April 25, 2025

RE: Sinndar Enterprises, Inc. (Tax Parcels 08154 000003, 08154 000005, and 08154 000005A)

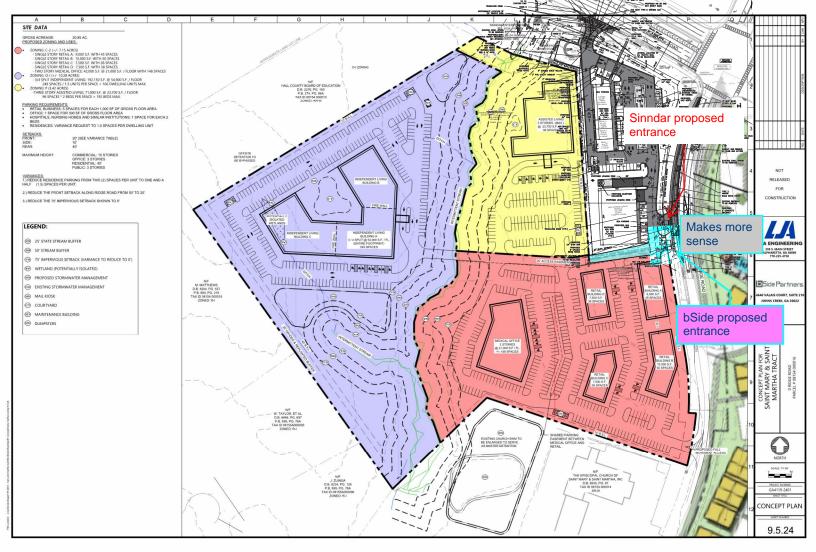
E) Height Restriction

Condition #7 of their PCD zoning approval states that the buildings shall be no more than 3 stories above grade. I would note that the site plan that accompanied their amended zoning application specified a future self-storage building containing 45,000 SF of storage with a 15,000 SF footprint shown as 3 stories. While travelers of Ridge Rd on the front may only see 3 stories, the residents backing up to this storage facility may see 4 stories if the Applicant later decides to fit the 45,000 SF into a smaller footprint by going higher on the back side. There is also no definition in the UDC for how big a "story" is. We would request that no building exceed 36 feet from any grade (not just front) including the decorative parapet needed to screen rooftop equipment from the future residential use. Below is the building presented in their PCD rezoning application package and their Special Use Permit application, which reflects no basement story to this building. Prior to any Board of Commissioners approval, we'd request renderings/elevations for all 4 sides.

- BLDG HEIGHT The pictures below give a more realistic perspective. That's what a 3-story self-storage facility looks like with a 30' building setback. Those roll-up doors are 7-ft. high and the height of the storage units on each floor is only 8-feet tall, yet the building is 42'-44' high. Please set restrictions on height. Allowed height should be less than normal given their reduction in setback. This building will be towering over us and the tiny 10' Buffer variance they were granted. With no definition of how tall a "Story" is in the UDC, I'd request a 36' height limit from ANY grade, not just the Ridge Rd. facing side. Just because they have offered to reduce from 4 stories to 3 stories doesn't mean the 4 story request was ever even in the neighborhood of reasonable.
